# Excavation Scope Final Design

Arup Final Design Kick-Off Meeting

November 7, 2017

# Changes from what you've seen in the PDR

# Changes to EXC scope – Infrastructure – 4850L Yates Shaft Brow

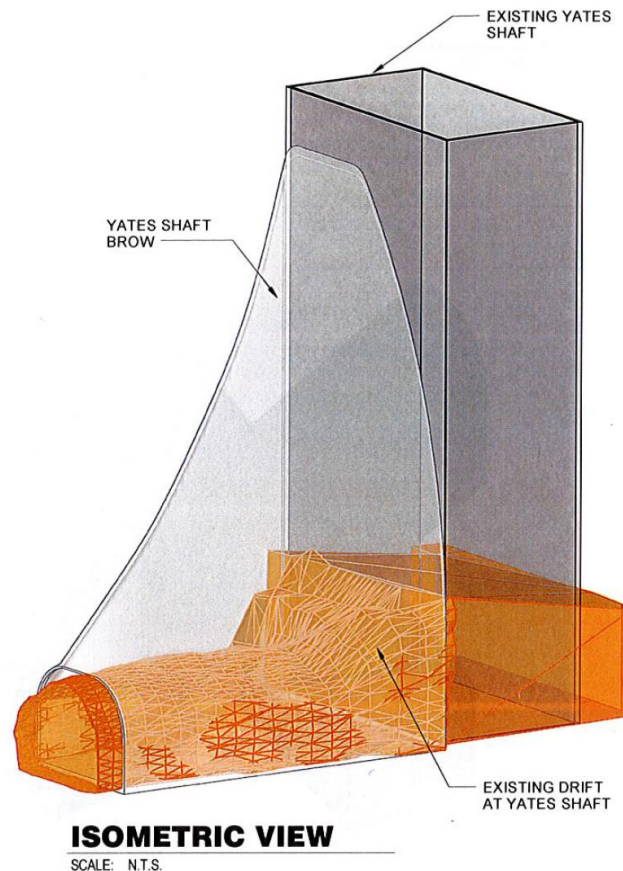
- The Preliminary Design included the excavation of the Yates Shaft brow. The completed logistics study determined this was not required.
- Final Design shall remove the 4850L Yates Shaft Brow excavation from the scope of work.

## Changes to EXC scope – Infrastructure – 5000L Decline Drift

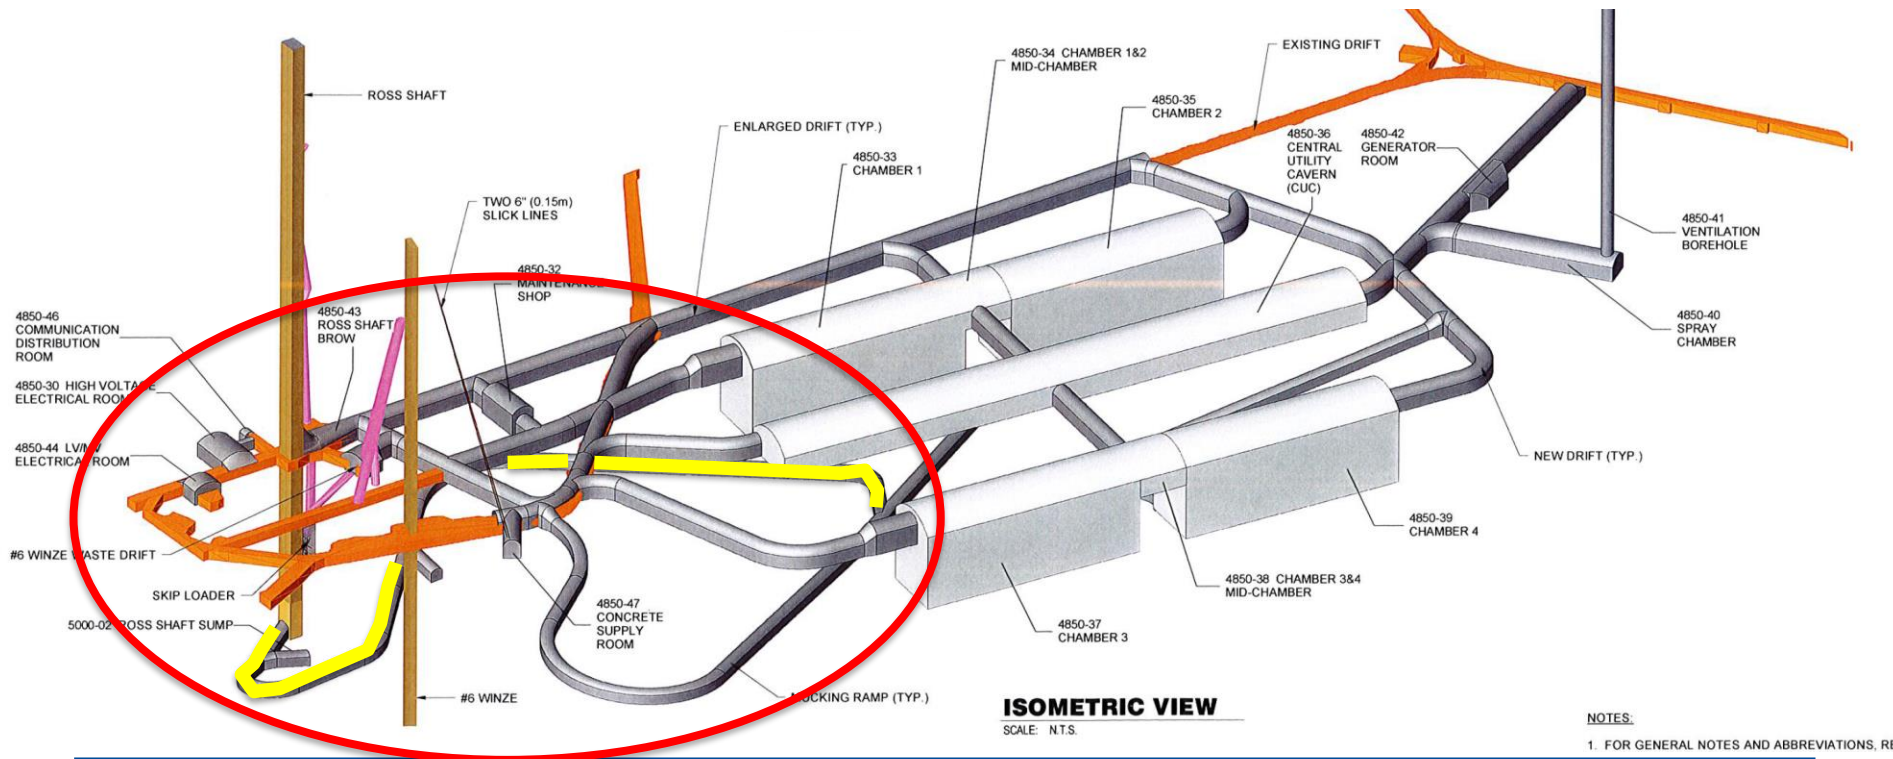
- The installed Ross Shaft collection system will eliminate the 5000L decline drift previously included in the PDR and may influence ventilation design.
- The Final EXC Design shall remove the 5000L decline drift from the scope of work.
- The Final EXC Design shall include a water management system to replace the collection system included into the 5000L ramp.

# Changes to EXC scope – Infrastructure – 4850L 17 Ledge Ventilation Route

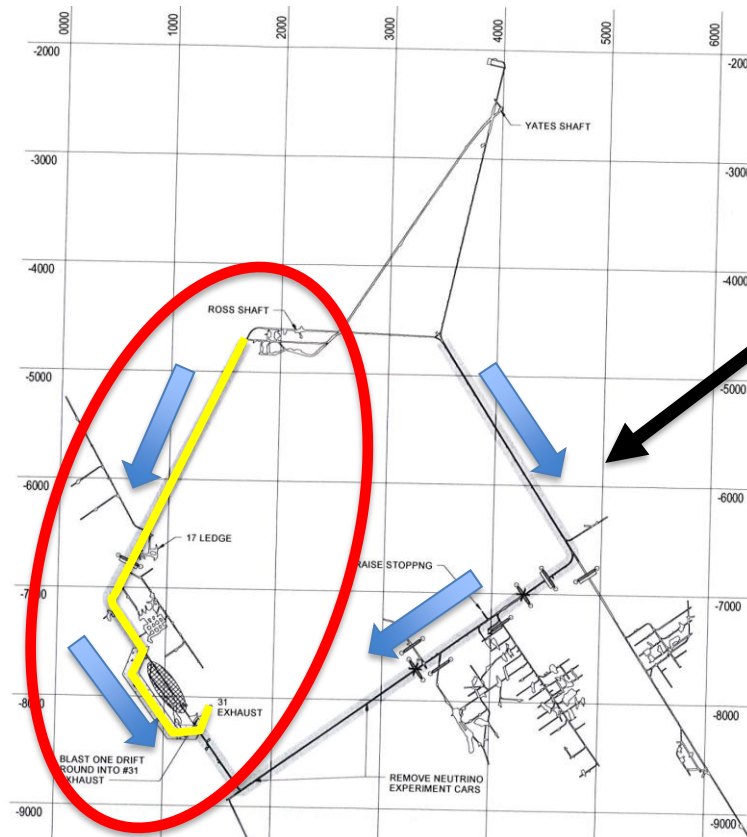
- The Preliminary Design included rehabilitation of 4850L 17 Ledge exhaust ventilation route for ventilation support for the LBNF excavation.
- The Final Design shall remove this from the scope of work.

# Changes to EXC scope – Infrastructure – 4850L Ross Shaft Brow & Access Drift Design

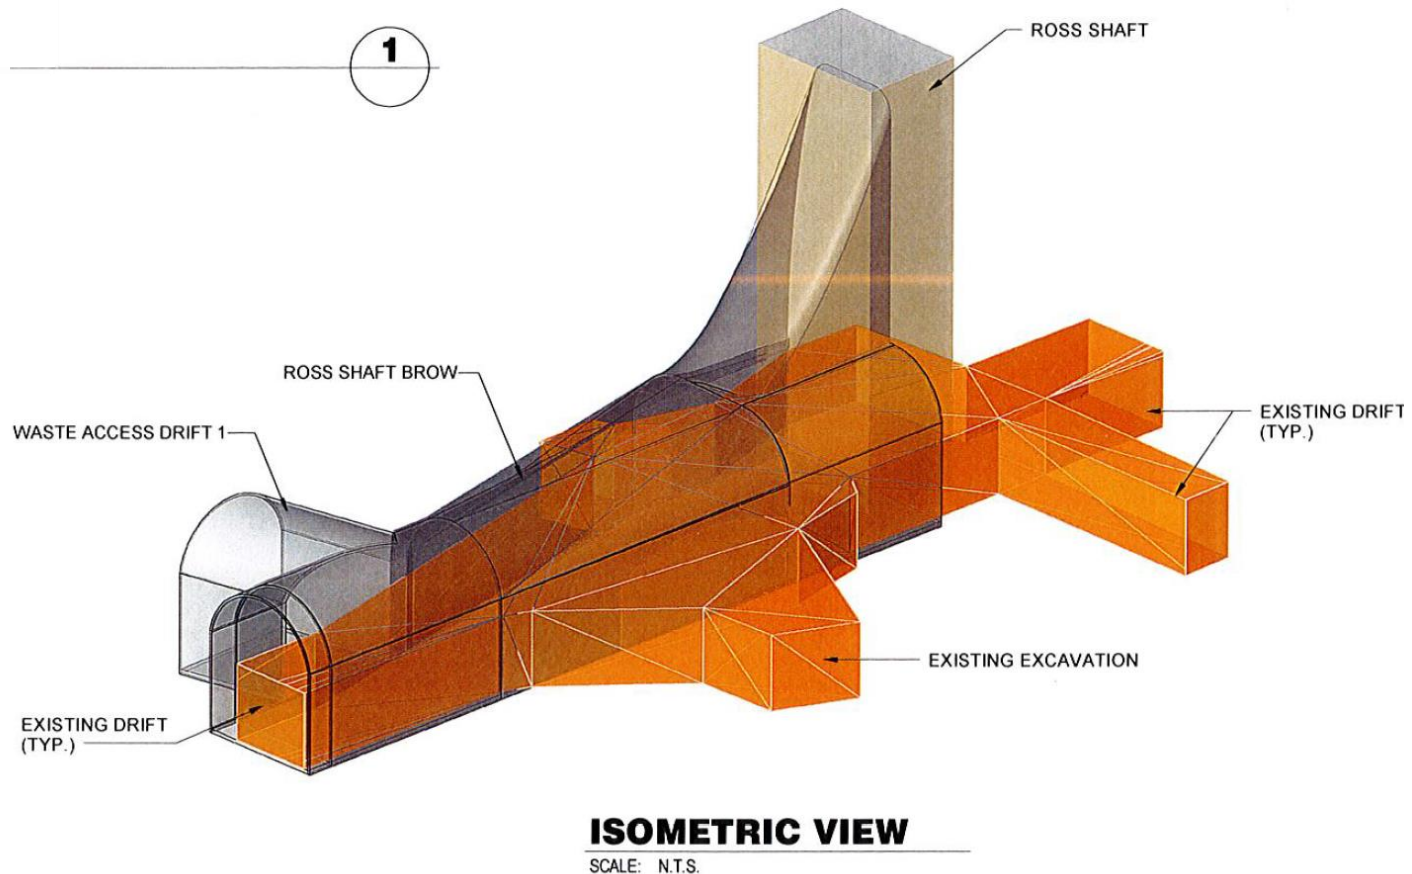
- The Final EXC Design shall include the findings of the Ross Shaft Brow Isolation and Drift Optimization Studies. KAJV to provide input.

# Changes to EXC scope – Infrastructure – 4850L Ross Shaft Brow & Access Drift Design

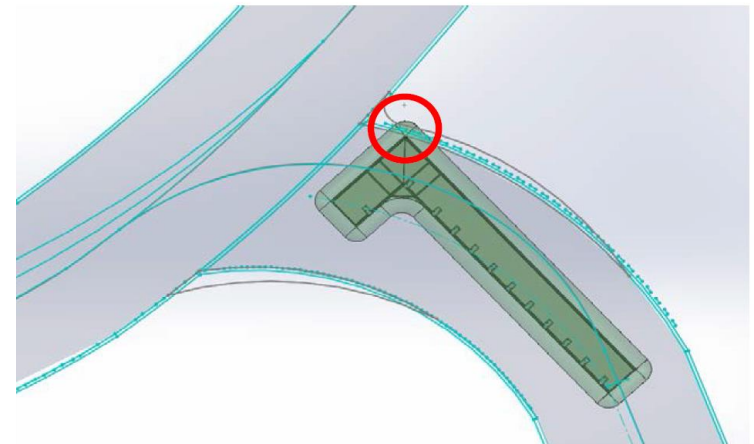
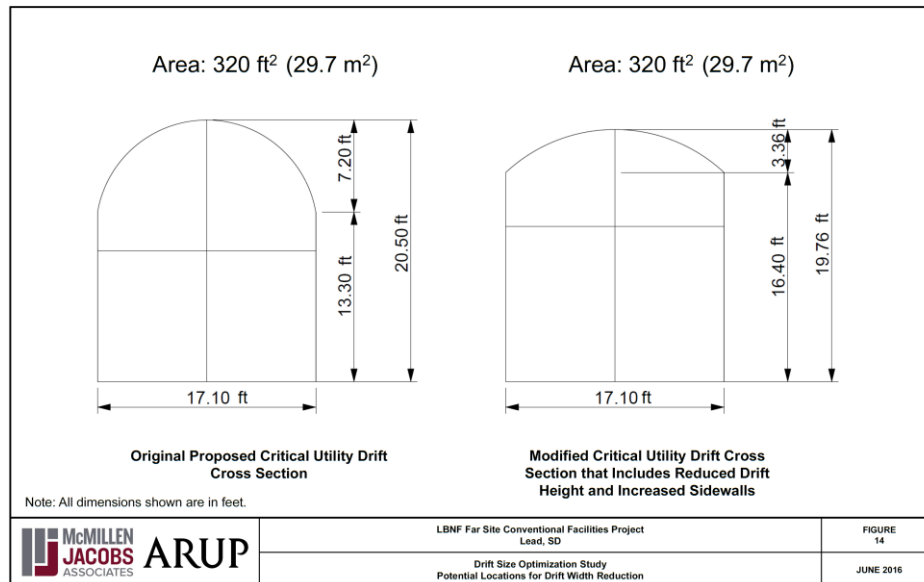
- The Final EXC Design shall include the findings of the Ross Shaft Brow Isolation and Drift Optimization Studies.
- “It is recommended that the critical utility drift cross section shown in Figure 14 be considered going forward to improve drift stability. Further, it is recommended that a five ft. (1.5m) radius is adopted for pillar chamfers and minor modifications needed made to cure radii at intersections to accommodate transportation of beams.” KAJV to provide input.

Corner Beam Transported through Intersection 12 on Side. Sidewall of drift encroaches into 1.5-foot clearance envelope.

# Changes to EXC scope – Infrastructure – 4850L Ross Shaft Brow & Access Drift Design

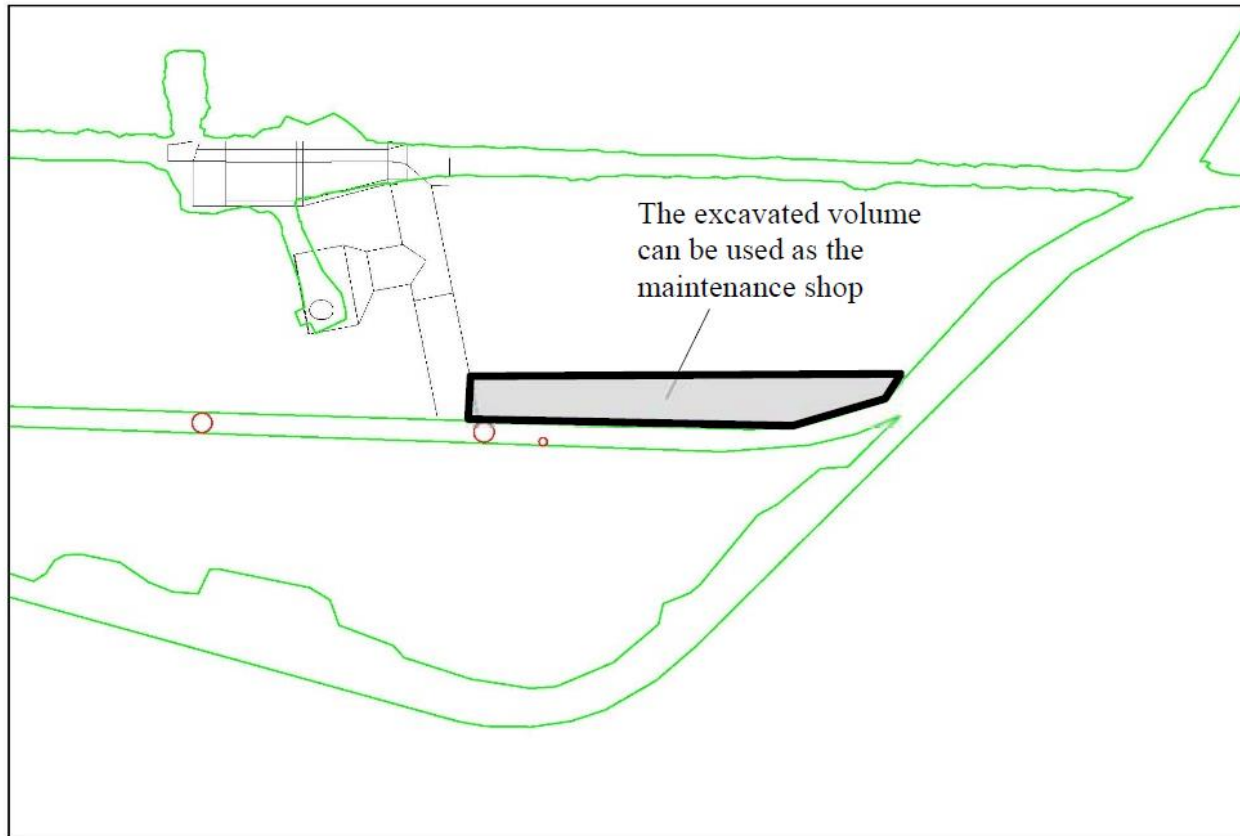
- The Final EXC Design shall include the findings of the Underground Electrical Substation Relocation Feasibility Study/Conceptual Design. KAJV to provide input.

# Changes to EXC scope – Infrastructure – 4550L Concrete Batch Plant

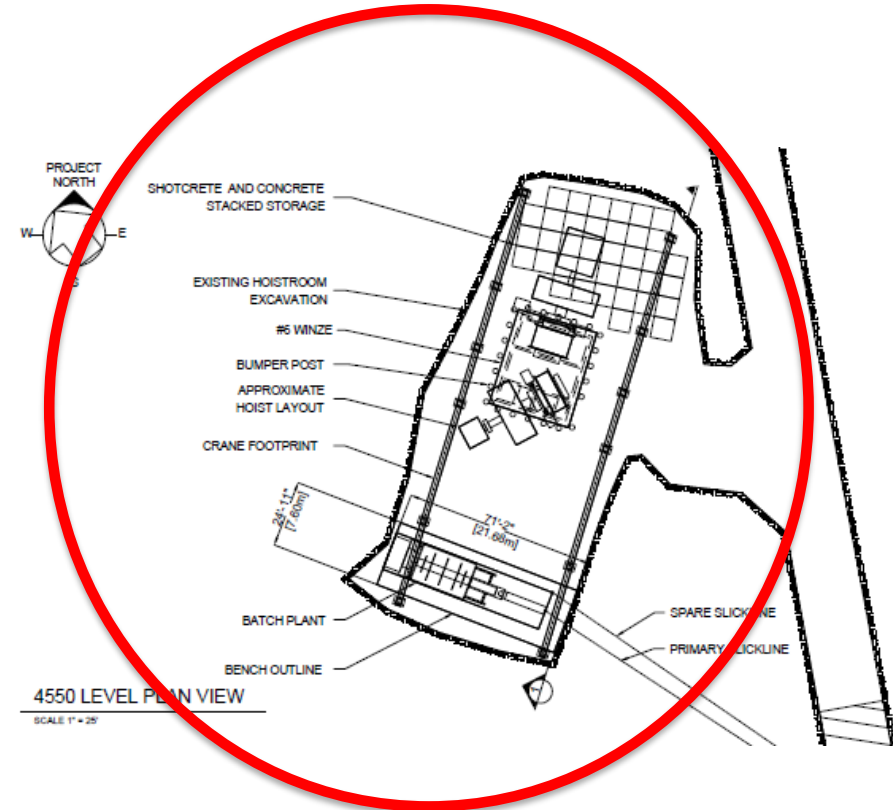
- The Preliminary Design includes a batch plant in the #6 winze hoist room on the 4550L, with boreholes delivering product to a remix bay on the 4850L.
- This is planned to be installed during the Pre-Excavation (1A) period, but KAJV may elect to postpone this if it's not deemed necessary to prevent interference with the main excavation process later.
- During the Final Design (by 30% design) KAJV is to inform FRA whether to further develop this method.

# Changes to EXC scope – Infrastructure – Geotechnical Site Investigation Core Drilling Hole Abandonment

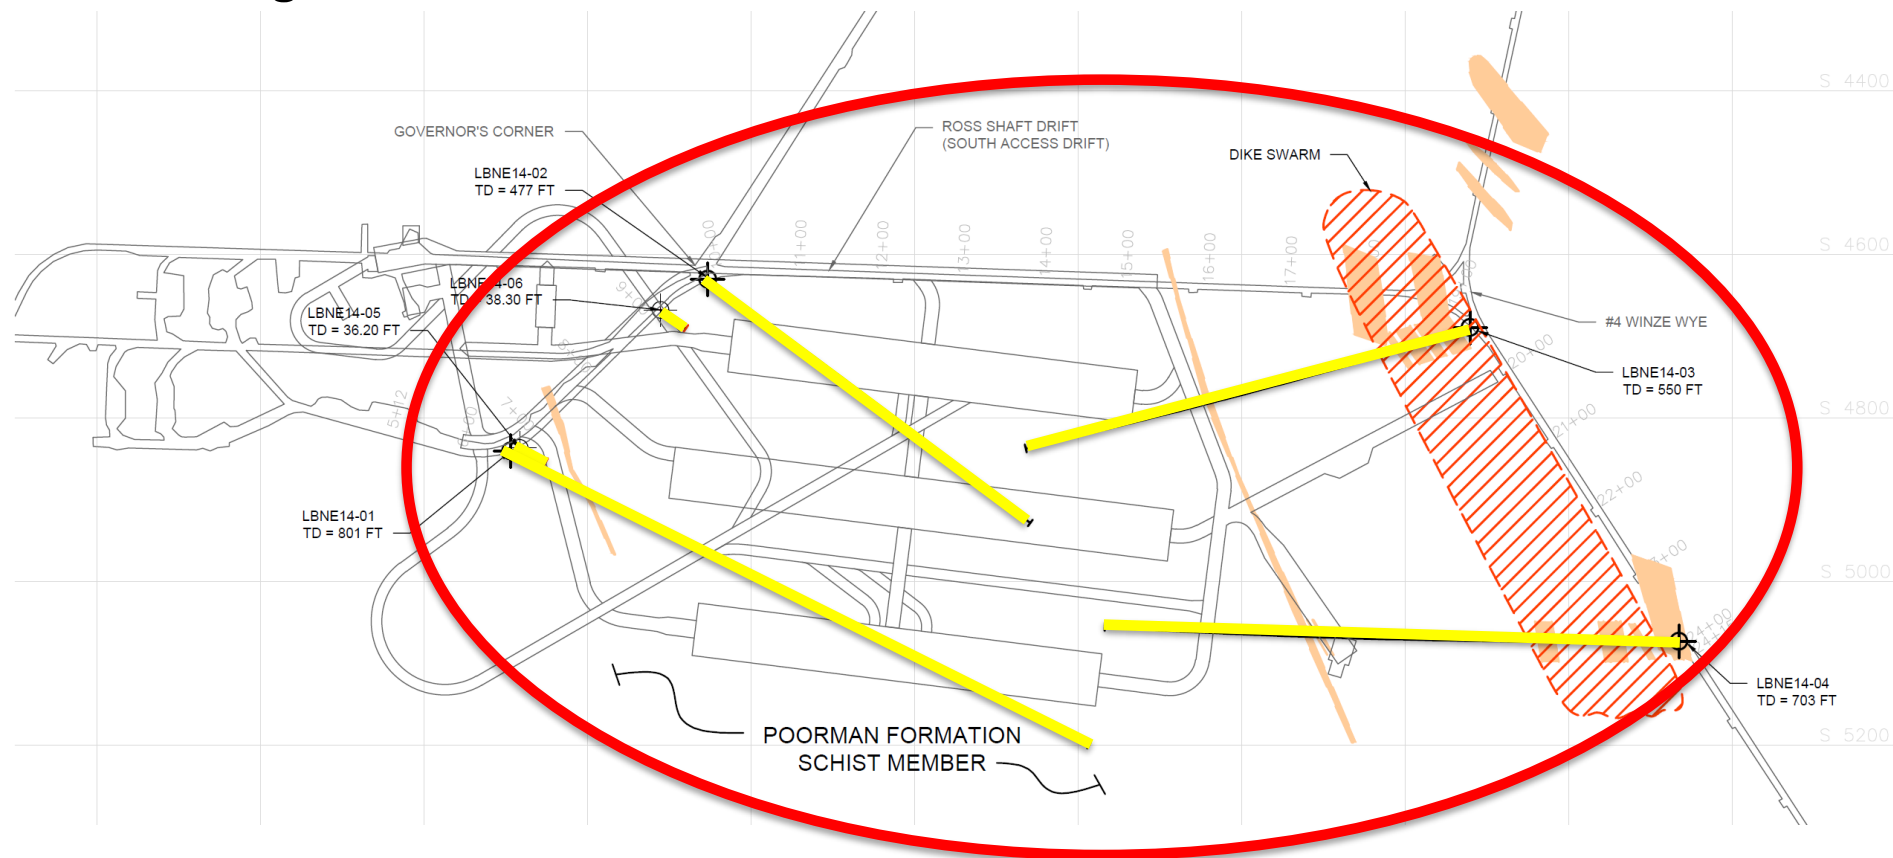
- The Final EXC Design shall include the full abandonment (drill hole terminus to collar) of the six LBNE Geotechnical Site Investigation core drill holes, or repurposing of these for geotechnical monitoring during excavation and long-term.

## Changes to EXC scope – Cavern Design – Chamber 3 & 4 Bulkhead & Mid-Cavern Access Drift

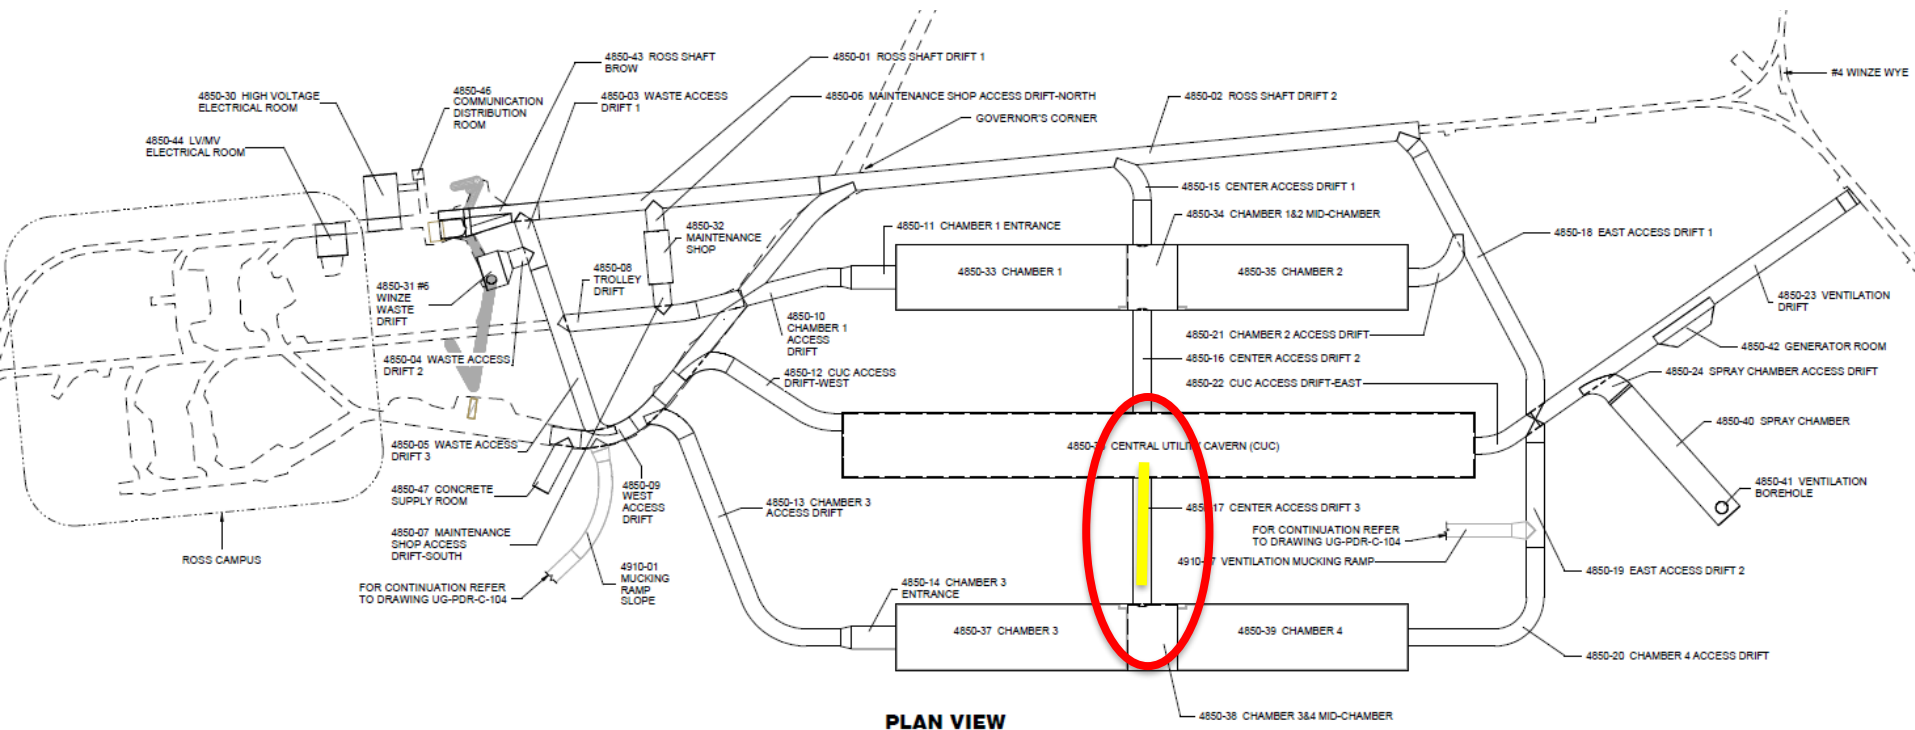
- The Preliminary Design includes a bulkhead between Chambers 3 and 4 to allow construction of a cryostat structure with concurrent excavation of chamber 4. This bulkhead required the access drift to be designed with an offset from the center alignment of the septum pillar.
- The Final Design shall remove this bulkhead design from the scope of work and include a shift of the center line for the mid-cavern access drift to the center of the septum pillar.
